REGIONAL REVIEW NOTICE

ARC REVIEW CODE: R1604061

Name of Proposal: Decatur Crossing Phase III

SUBJECT: **Transportation Division Review of DRI # 2558**

CONCEPTUAL
SITE PLAN

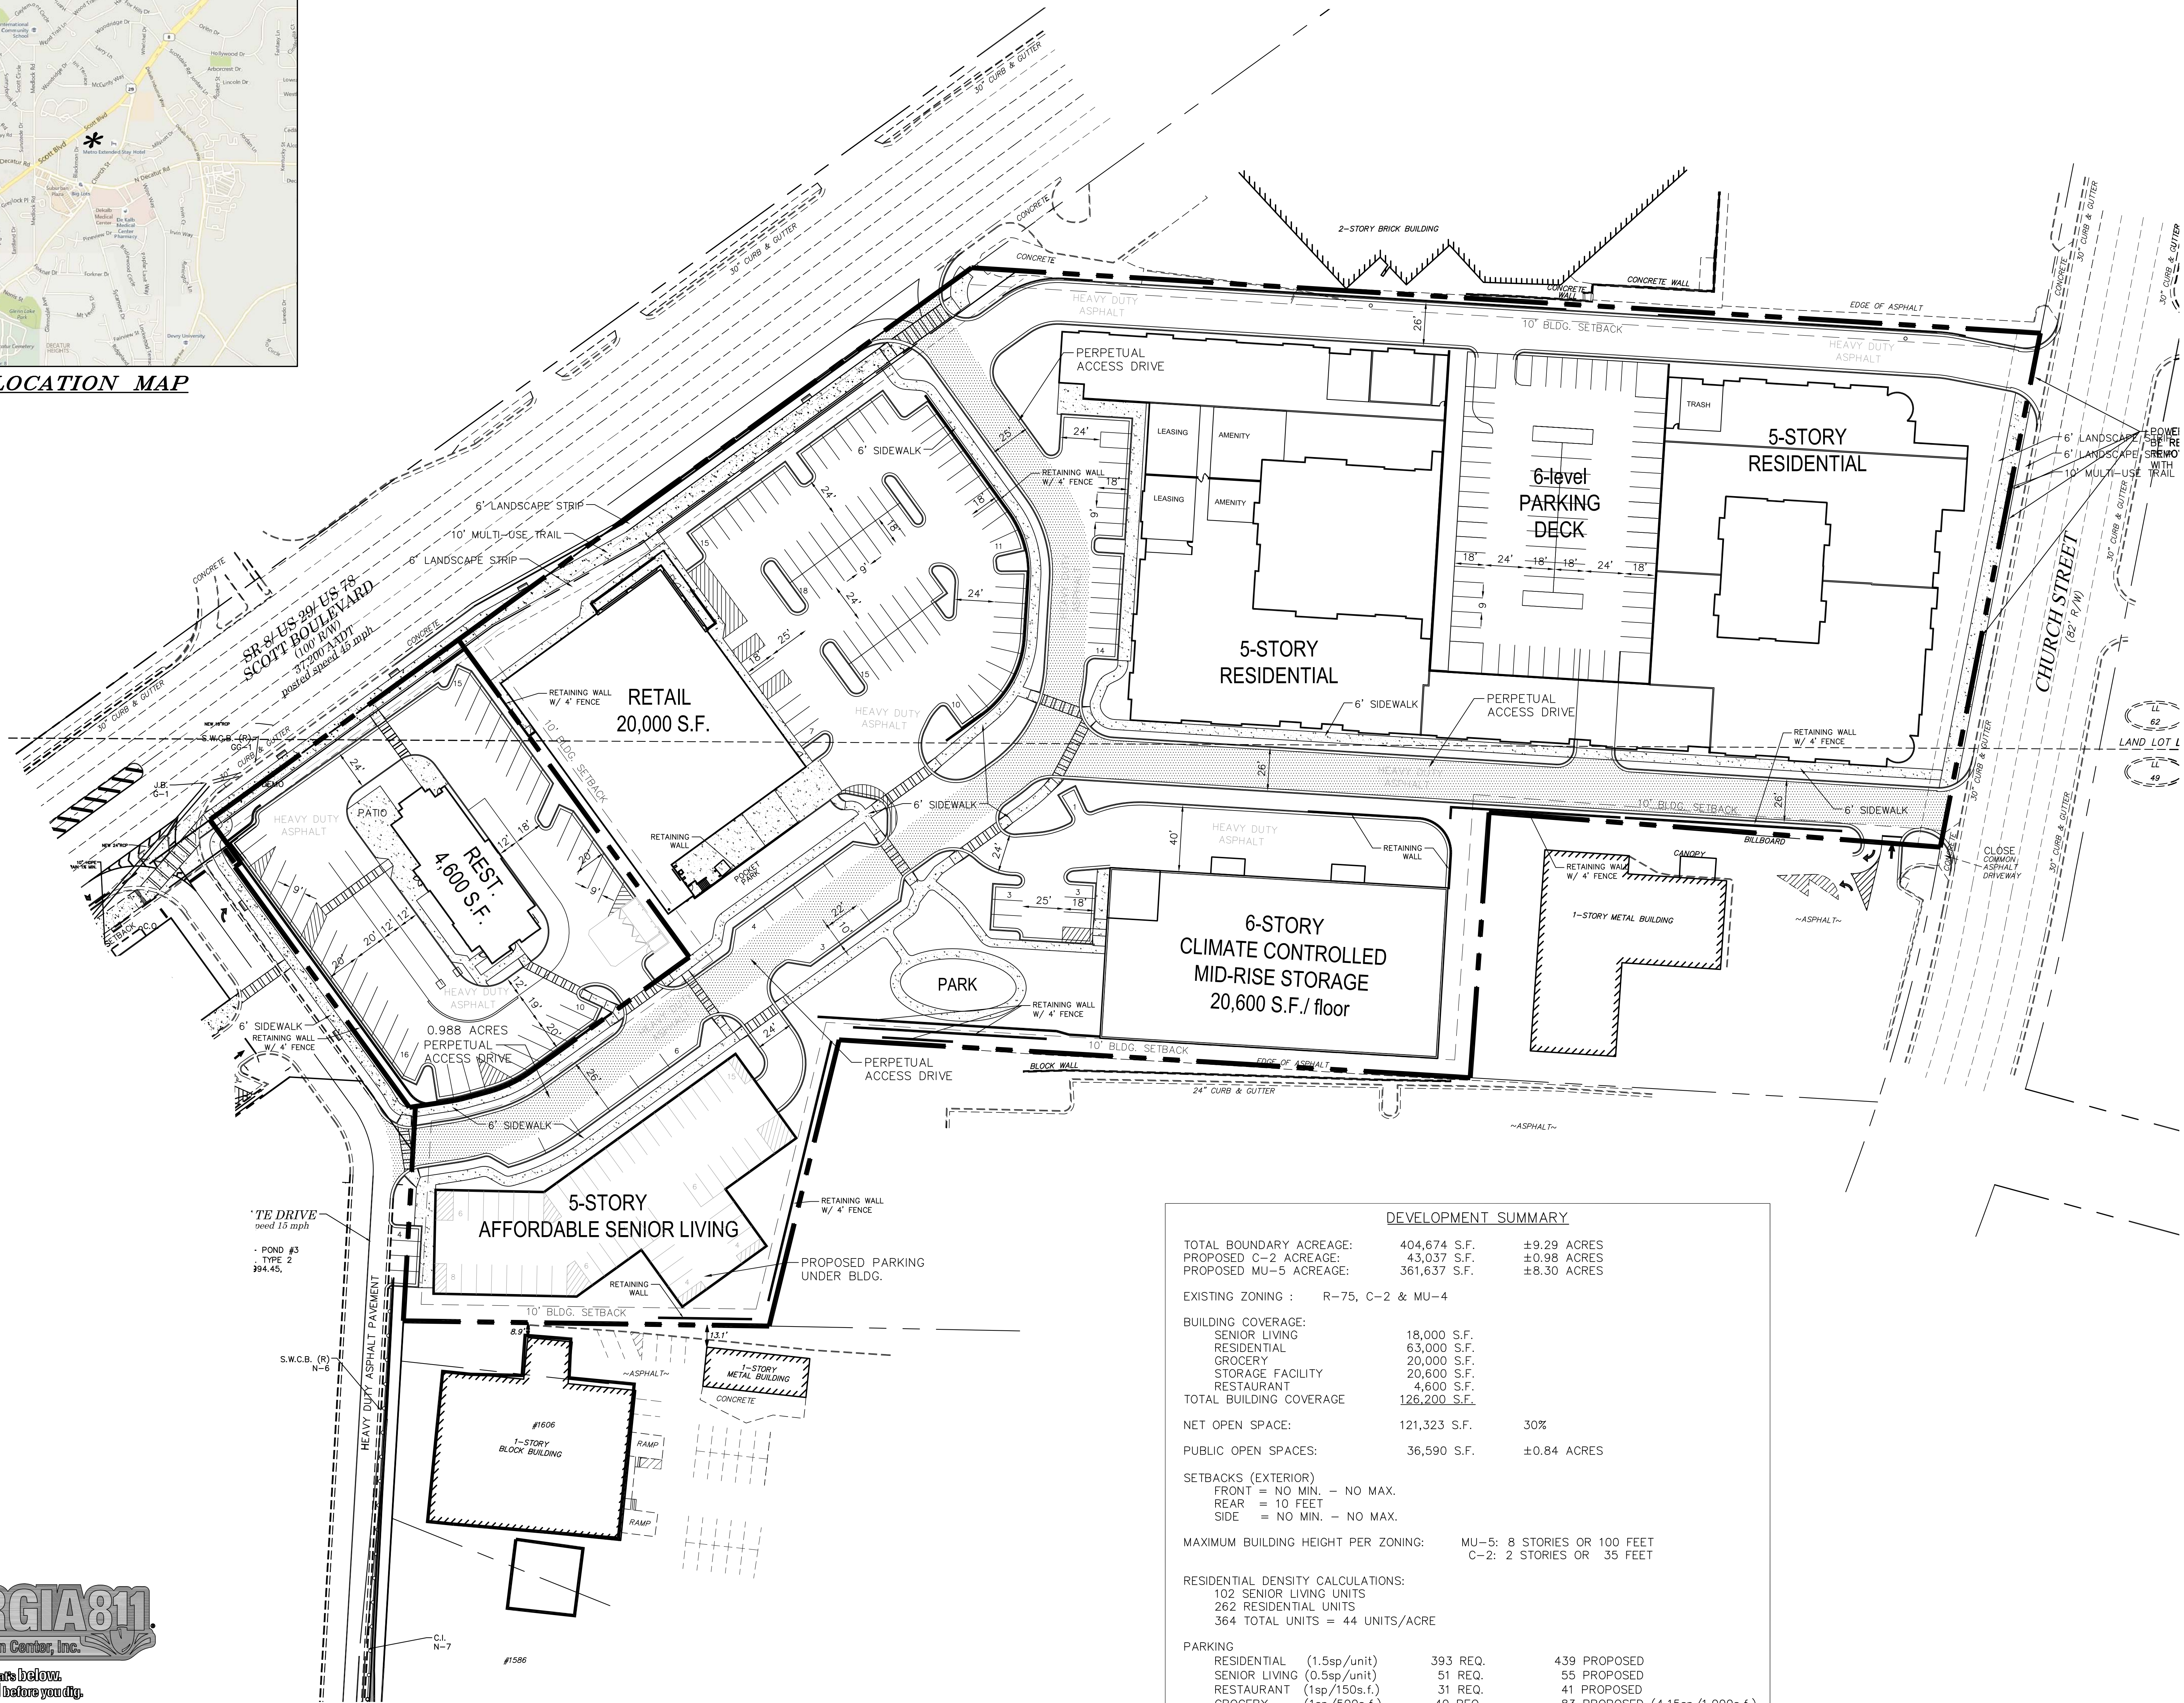
1. Increase sidewalk widths internal to the development from 6' to 8'
2. Provide covered bicycle parking in convenient locations
3. The new development is likely to make left turns out of Tuxworth Circle more difficult and possibly dangerous. Consider realigning the entrance to the development with Tuxworth Circle driveway to control all turning movements, or investigate other solutions to allow for safe left turns for residents of the Tuxworth Springs complex.
4. Redesign/re-orient the free-standing restaurant and retail buildings along the Scott Blvd frontage and locate parking in the rear, or share with other uses, to provide a more pedestrian-friendly design, consistency with Phase 1 development, consistency with Lifelong Communities principles and goals of

5. The multi-use path facility planned for Church St. should be the same typical section as the programmed Church Street bicycle and pedestrian project (DK-406) in Decatur for continuity purposes.
6. Provide a 10' multi-use path on the service alley along the northern boundary of the development, connecting Scott Blvd and Church St.
7. To mitigate the induced traffic from this development, and the lack of transit (only one existing bus route), provide reserved spaces for zip car and drop-off lanes/spaces for Uber/Lyft/Taxis and for Cliff Shuttle.
8. Align the internal (unnamed) southwest-northeast street from Phase 2 with internal (unnamed) street on Phase 3, thus removing the "dogleg" at the Phase 3 entrance and reducing traffic back up.
